# Request Summary

- Requesting approval of Final Development Plan, Design Review, Conditional Use, and Variances for a gravel lot and garage
  - Zoned OCT – Office, Commerce, and Technology
  - 2 acres
  - Proposed use is landscape company w/outdoor storage
  - Outdoor storage is a conditionally-permitted use
  - Site currently contains single-family home (to remain)
  - Existing 4 ft chain link fence

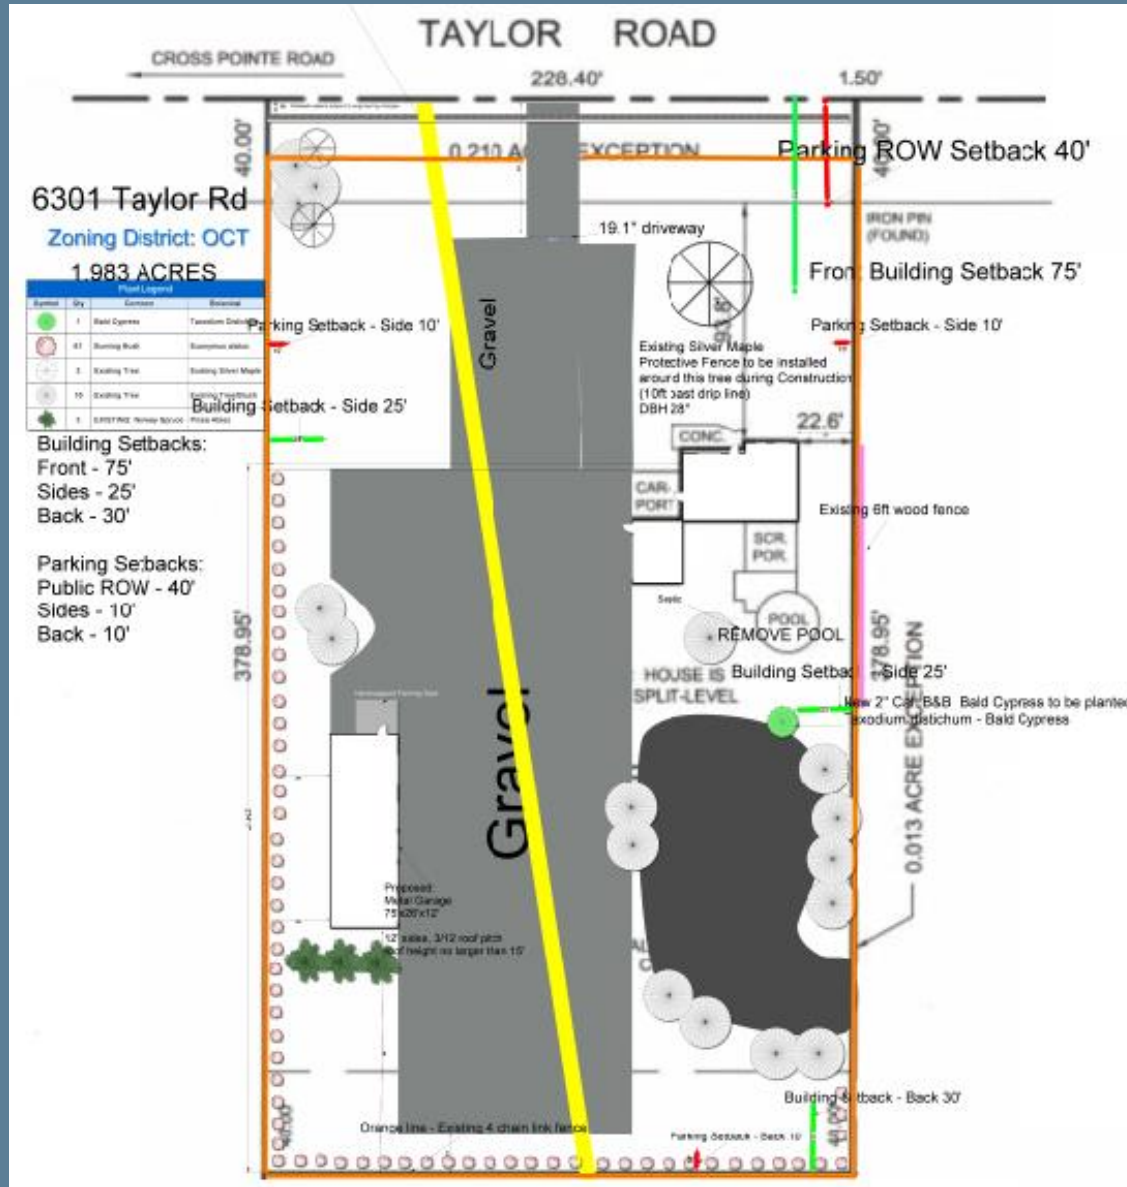
- 1,950 SF metal garage
  - Prefabricated metal structure
  - Used for storage
  - Set back ~230 ft from Taylor Rd
  - 15 ft at tallest point
- Approx. 39,000 SF gravel lot
  - Variance requested – gravel is not a permitted material
  - Used for outdoor storage
    - CU approval required
  - All screening requirements are met through fences and 61 proposed burning bushes
